Federal Recall Information

09KWA

Insufficient U-Bolt Torque on Airglide 400L Rear Suspension

Fig. 1

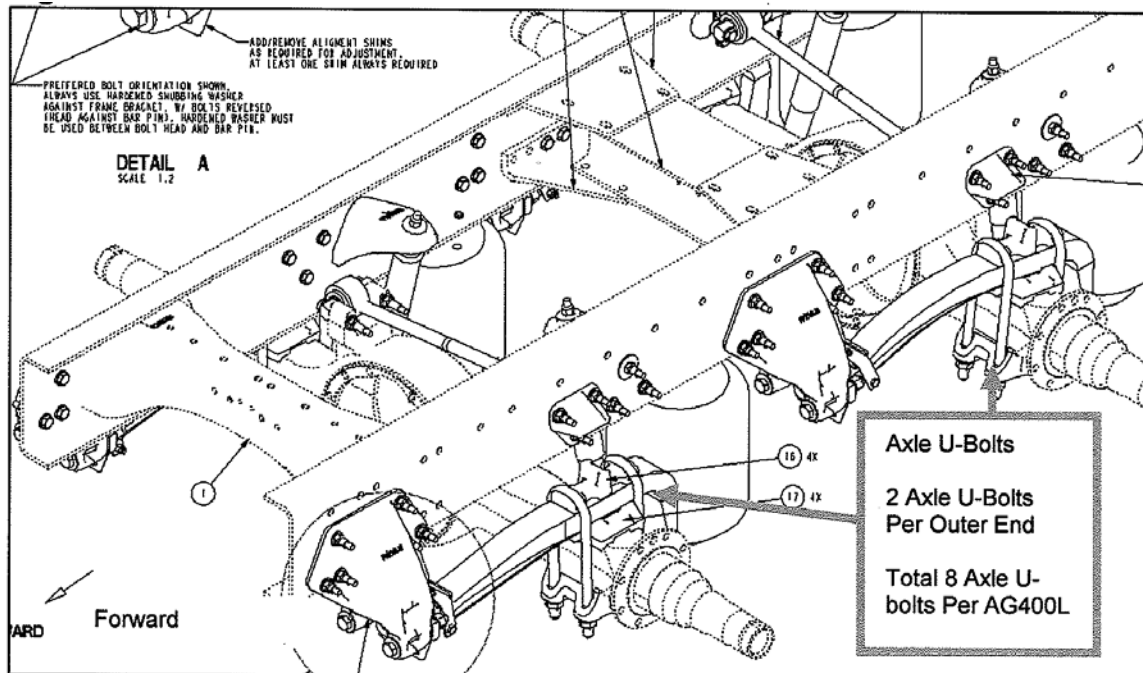
The axle u-bolts attaching the axle to the suspension leaf spring on certain AG400L rear suspensions may have received insufficient fastener torque during the installation process (Ref. Figure 1 & 2). The insufficient torque may allow the axle U-bolt to become loose, which may cause vibration in the rear suspension. If multiple fasteners were to become loose, the U-bolt holding the axle may lose clamp load and the rear axle may shift relative to the rear suspension leaf spring, which might result in an accident. This condition was determined by Kenworth to be a safety-related defect.

The remedy of the recall will involve inspecting the axle u-bolts for visible defects including bent and/or smashed threads and re-torquing the axle u-bolts to factory specifications.
